B I D A D D E N D U M 0 5

The items set forth herein, whether of omission, addition, substitution, or clarification are to be included in and form a part of the construction documents for the project listed above.

ORANGE-ULSTER BOCES
AXELROD - MAIN
BUILDING
ADDITIONS +
ALTERATIONS
53 GIBSON ROAD
GOSHEN, NY 10924

1 MECHANICAL - FIRST FLOOR DEMOLITION PLAN - PART B
1/8" = 1'-0"

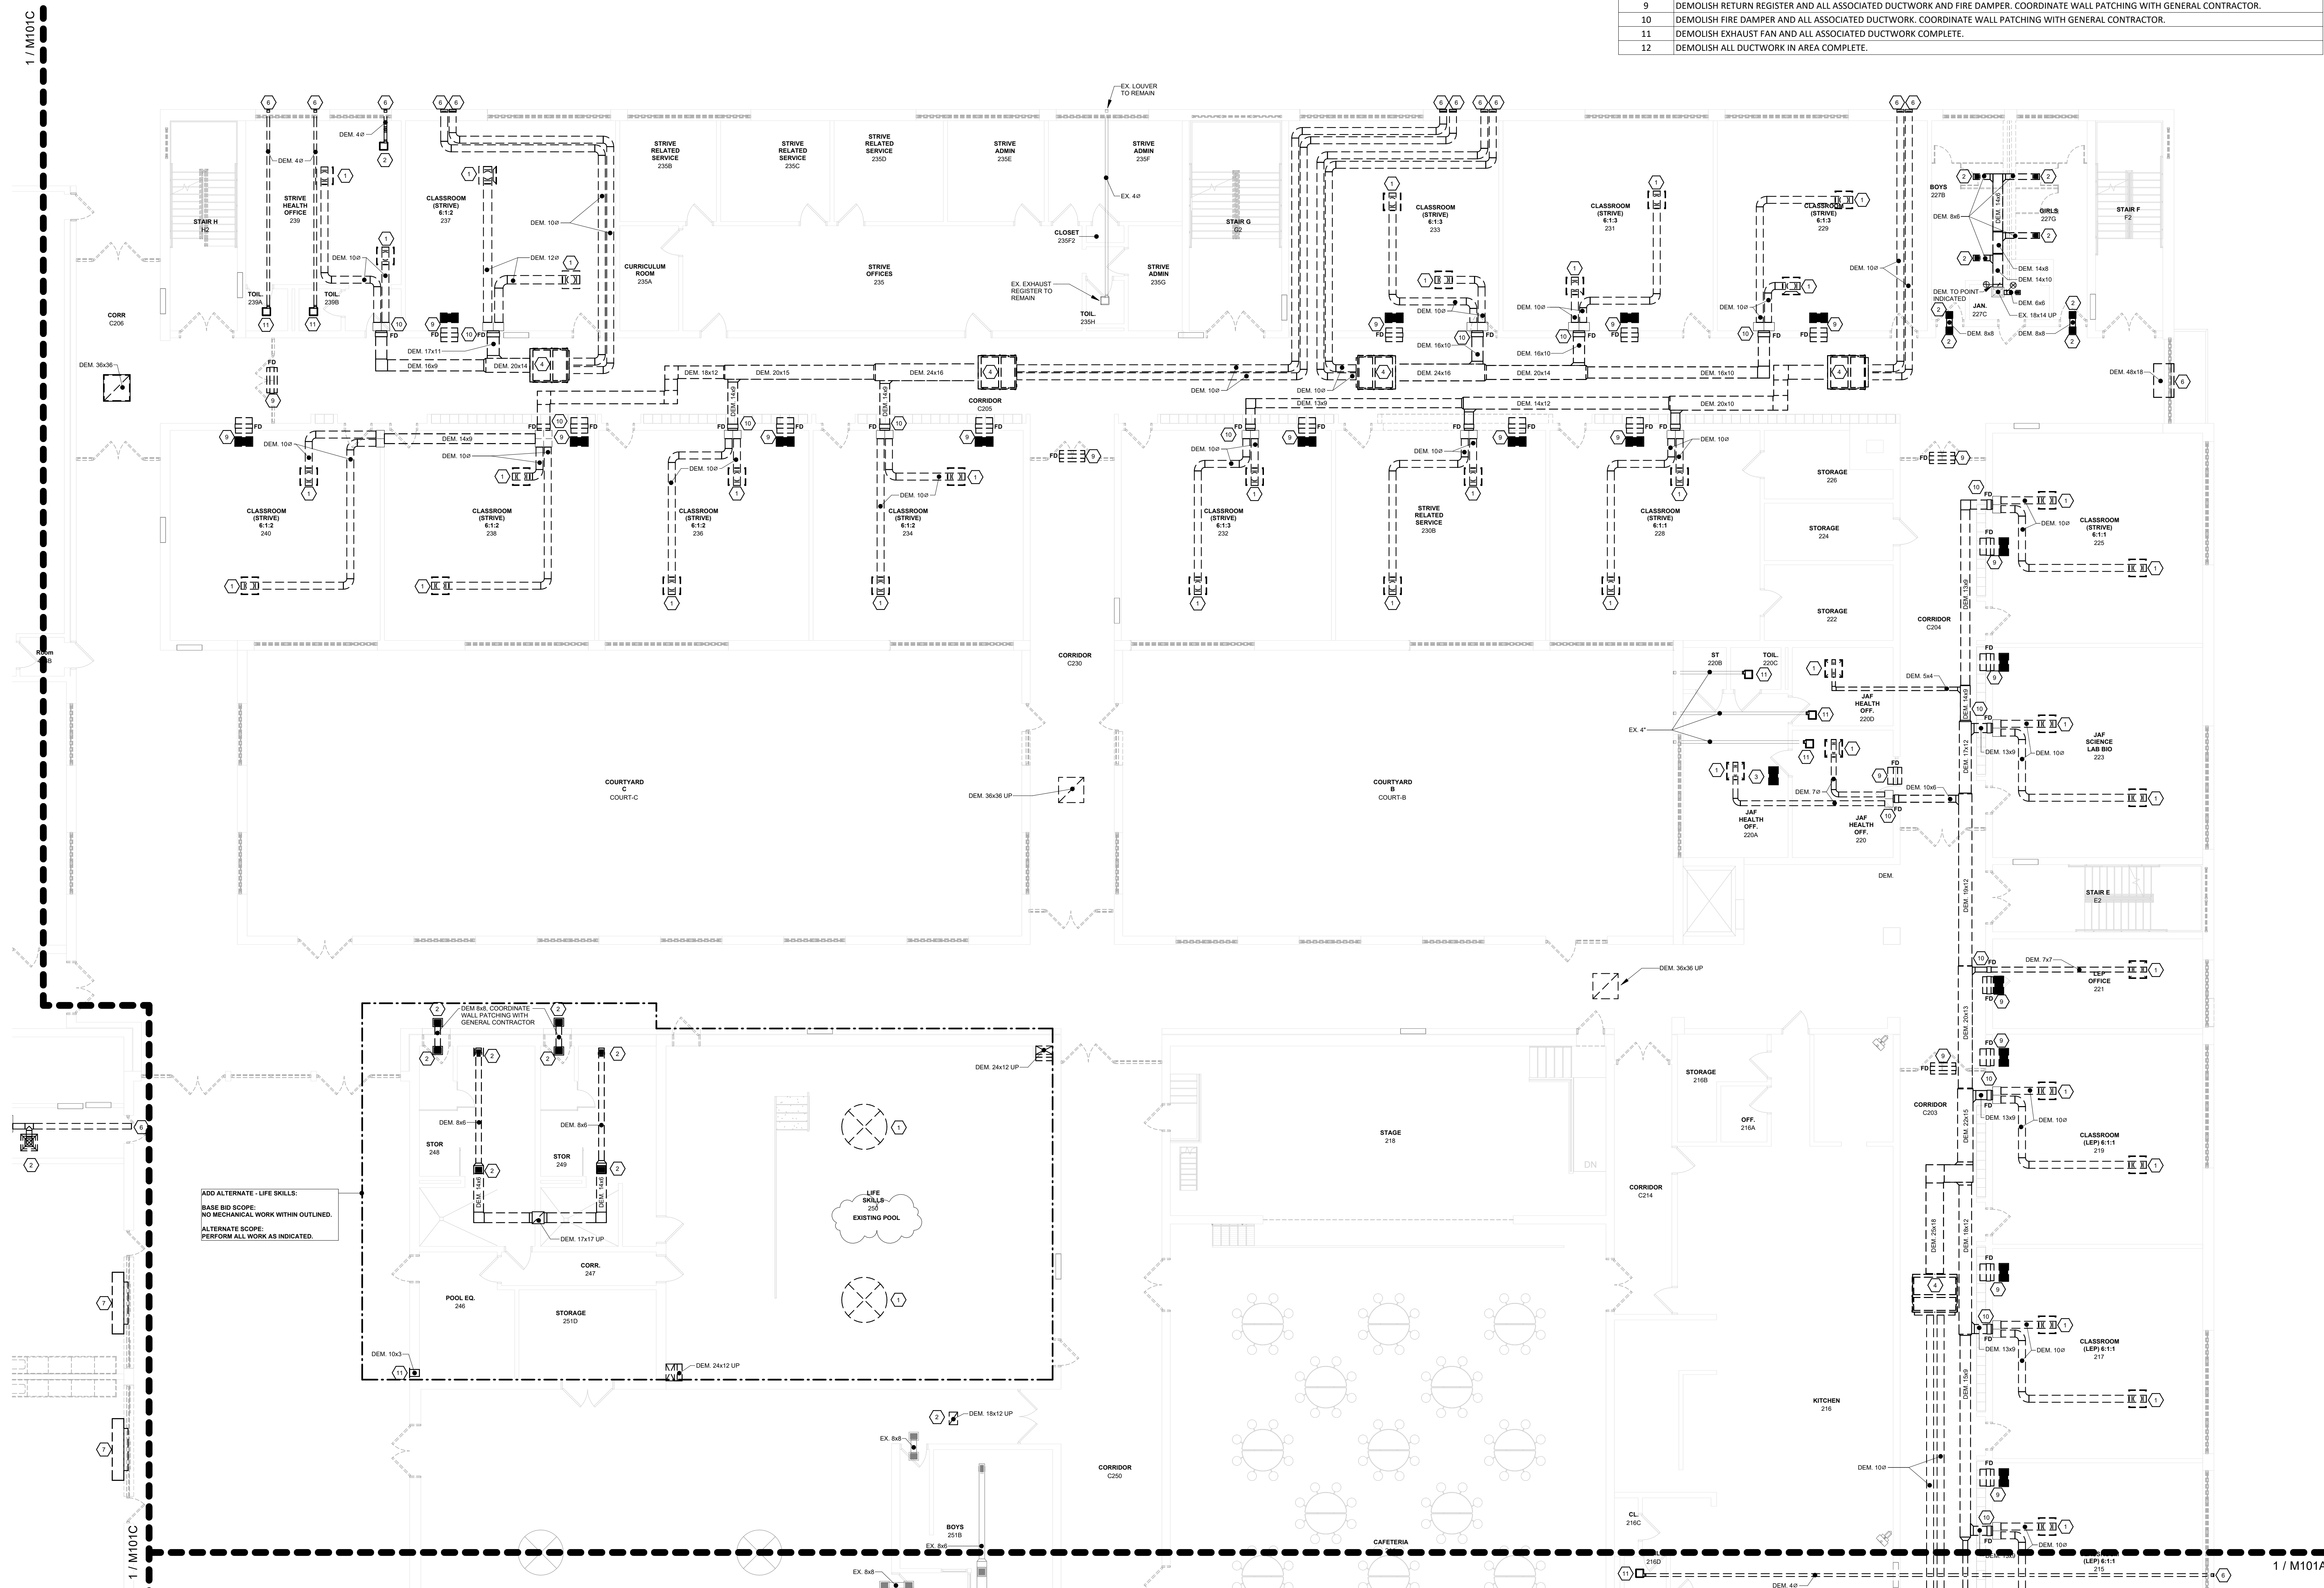
- a. Drawing M101B – Mechanical First Floor Demo Plan Part B
 - b. Drawing M111B – Mechanical First Floor Piping Demo Plan Part B
 - c. Drawing M200B – Mechanical Ground Floor Plan Part B

M200B

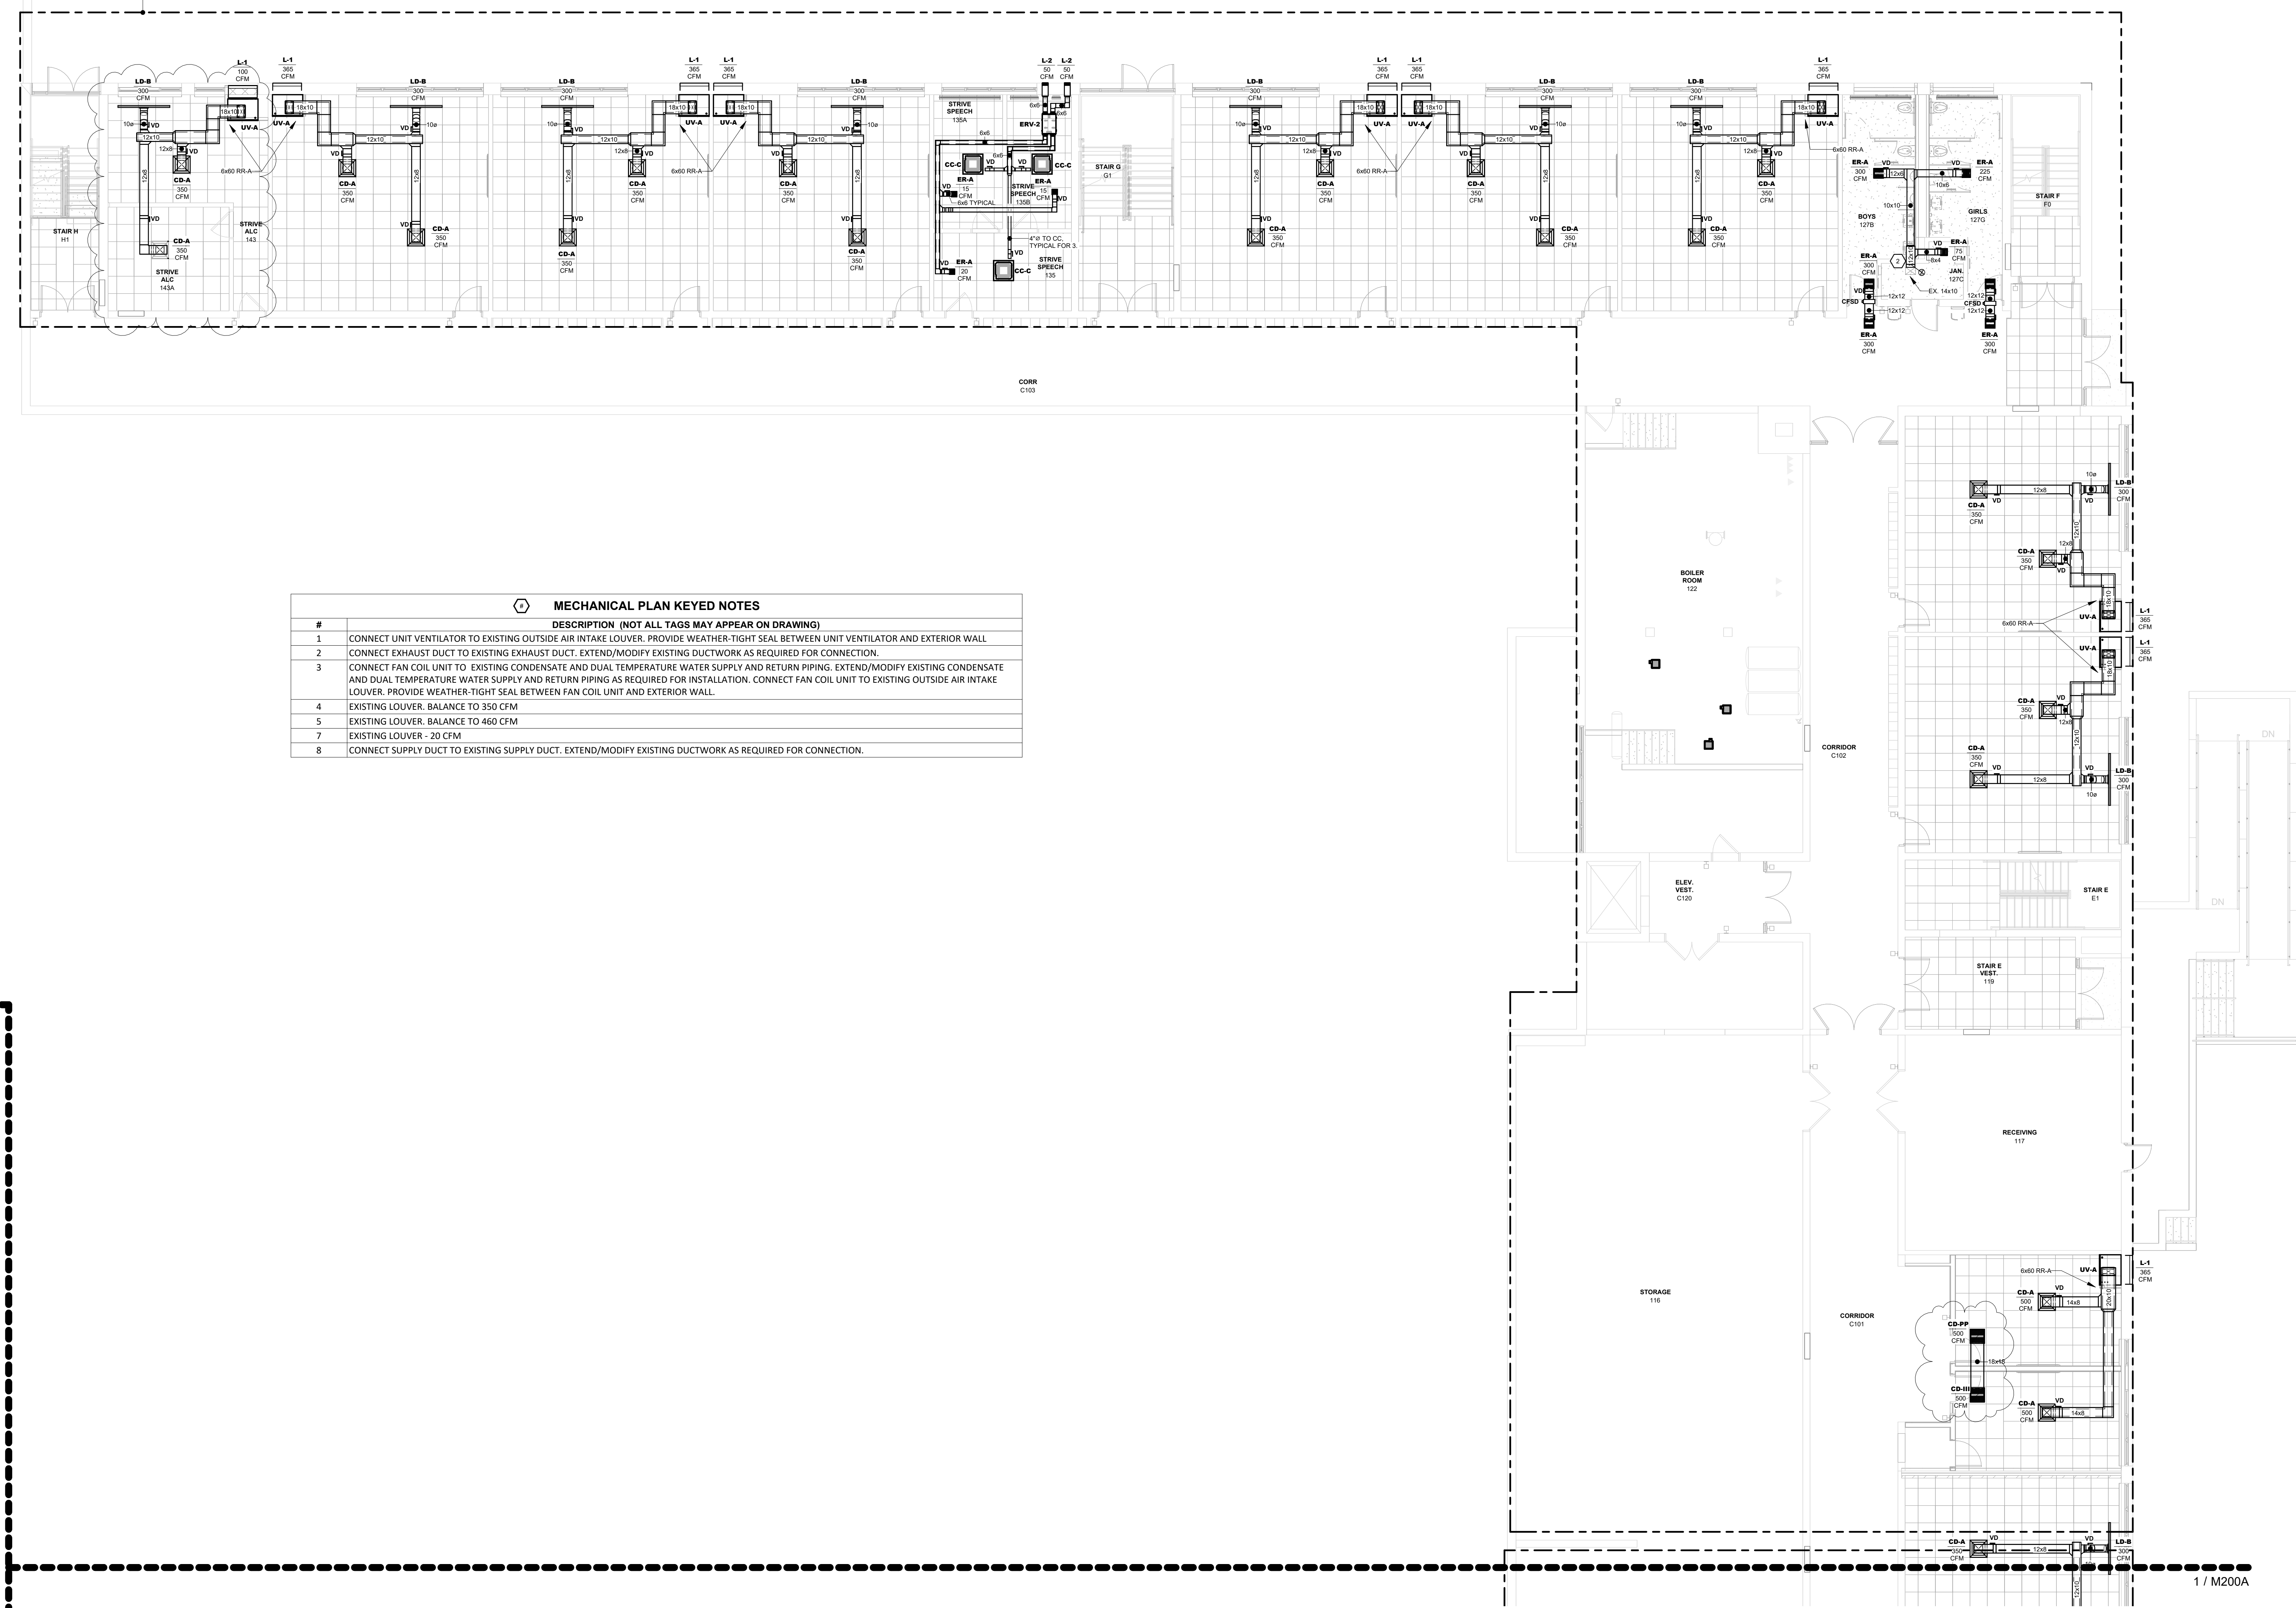
ADD ALTERNATE - GROUND FLOOR:
BASE BID SCOPE:
NO MECHANICAL WORK WITHIN OUTLINED.
ALTERNATE SCOPE:
PERFORM ALL WORK AS INDICATED.

EXIT SIGNS AND EMERGENCY LIGHTING NOTES:

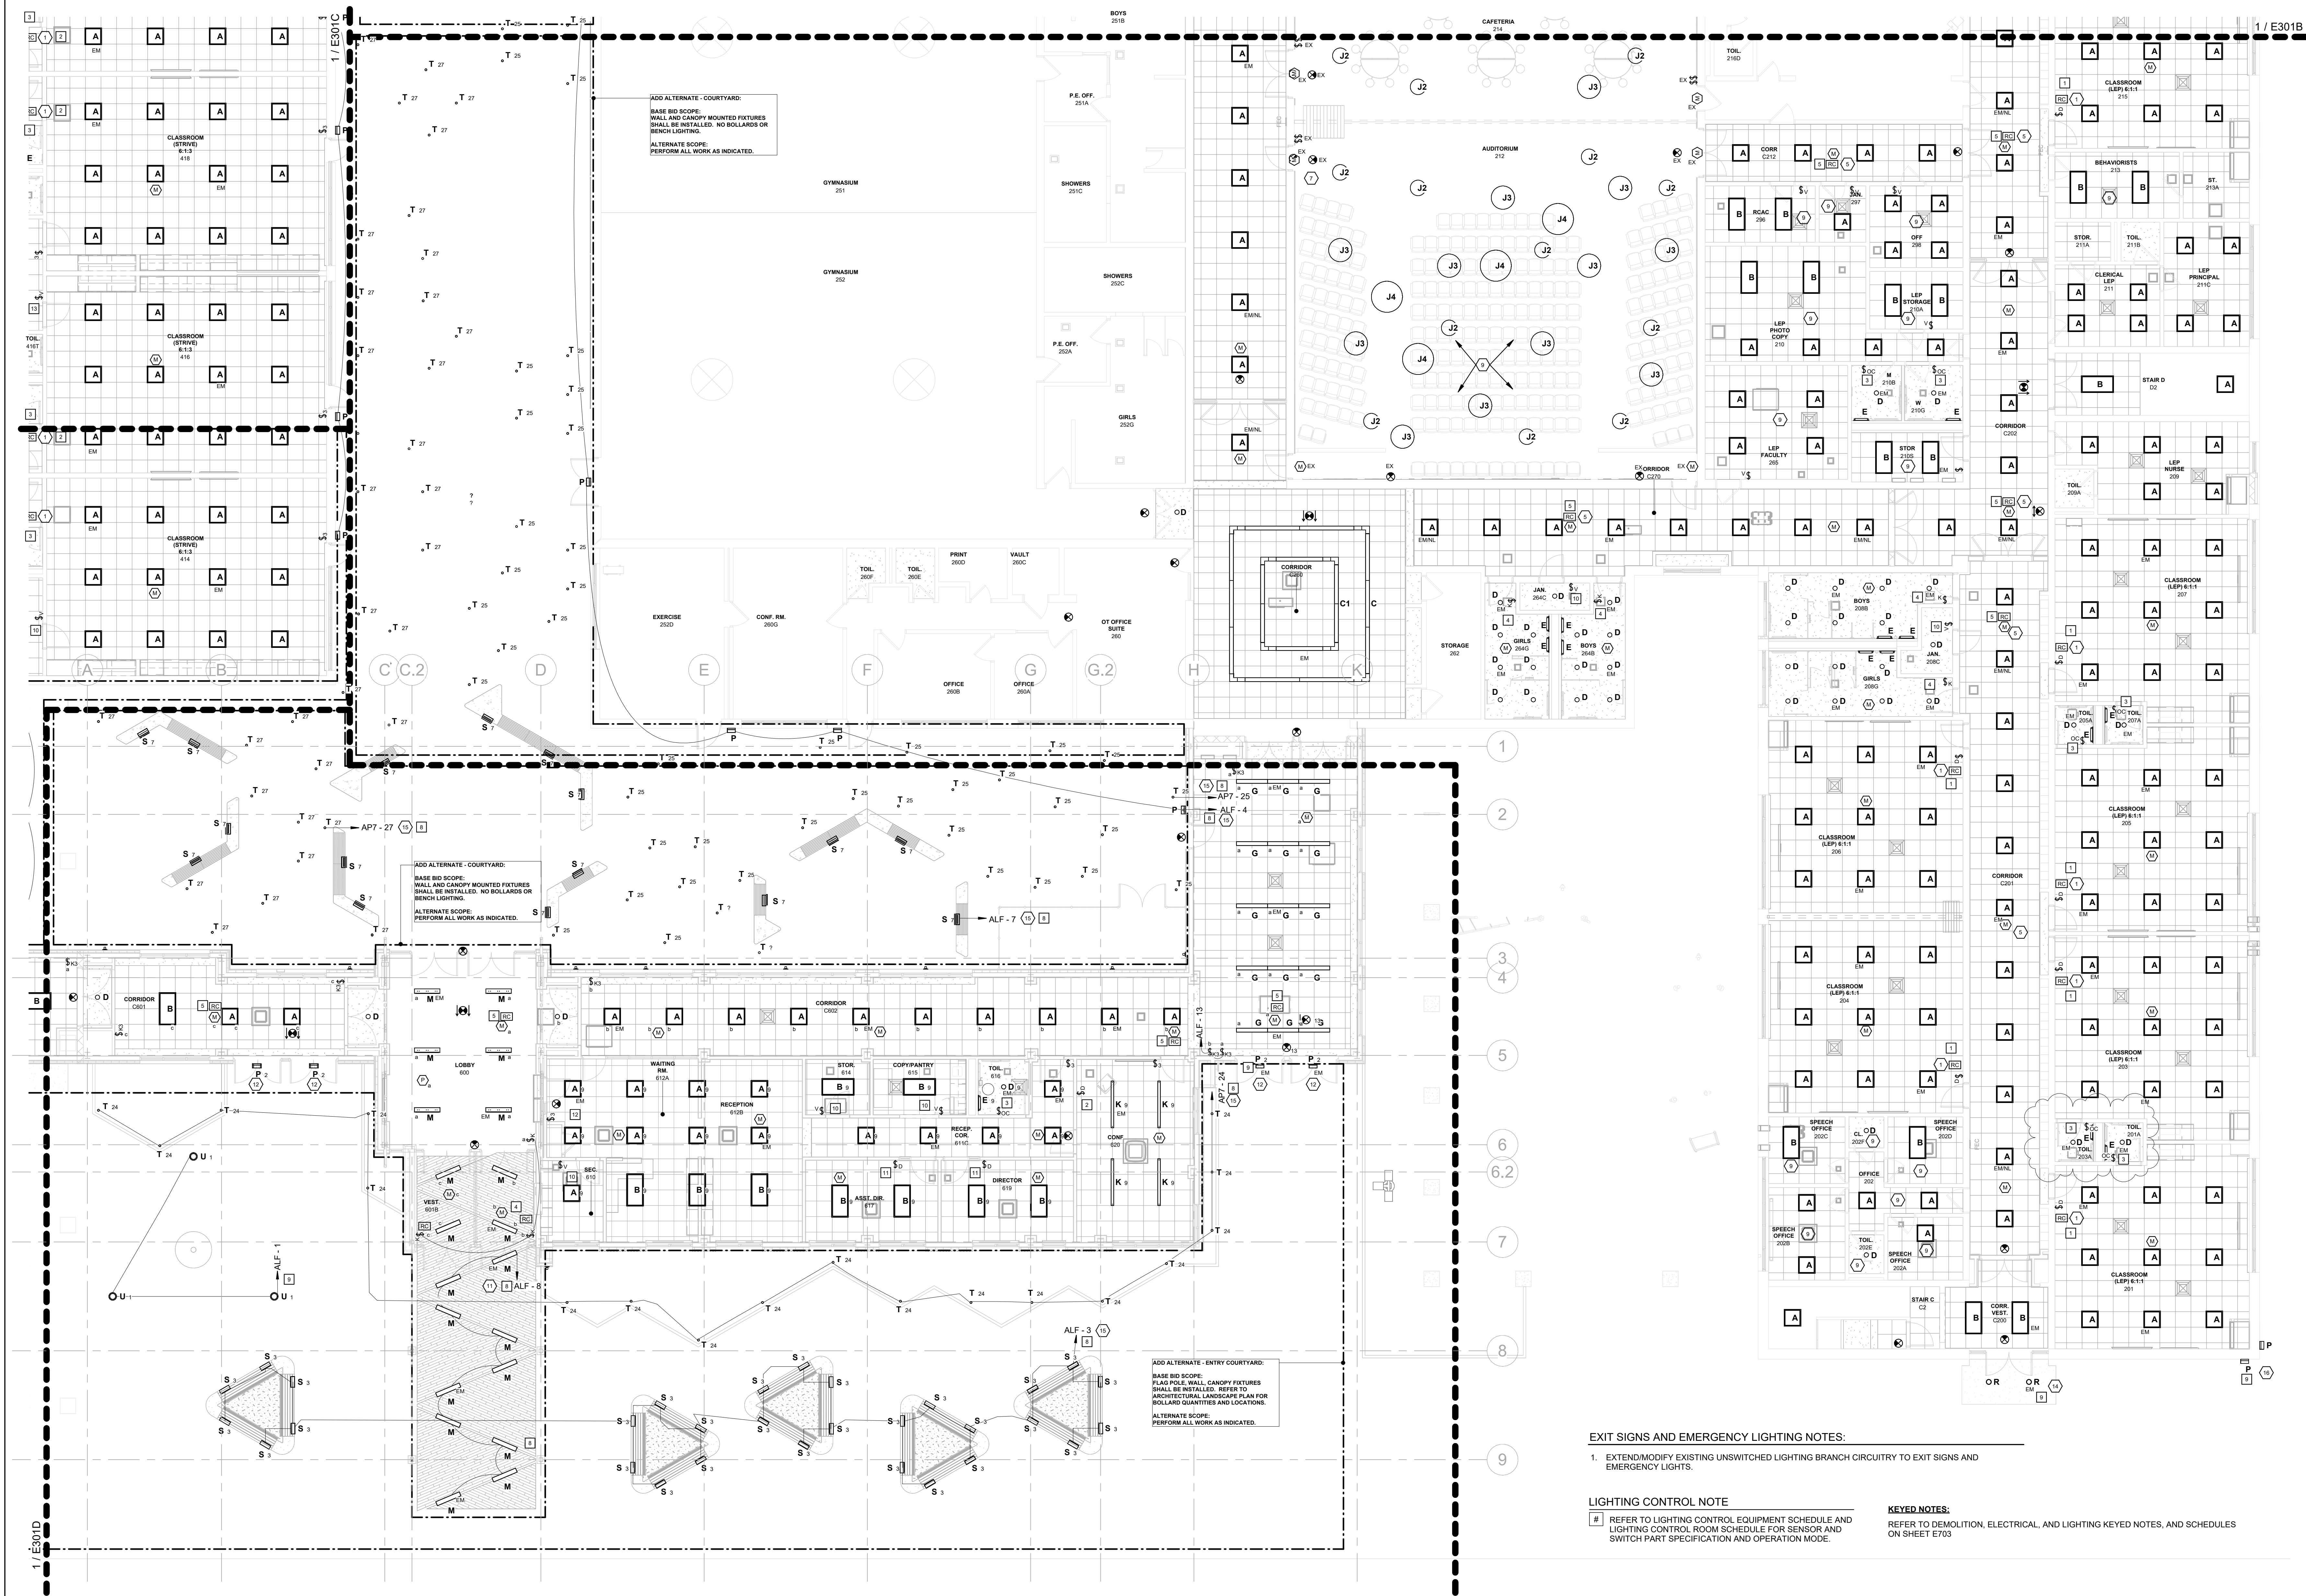
- 7.8 RFI Question – There are unlabeled light fixtures throughout Drawings E300B, E301A, E301B, E301C, E301D, E302A, E302B. Please advise.
RFI Response – See attached revised electrical drawings with light fixtures labeled.
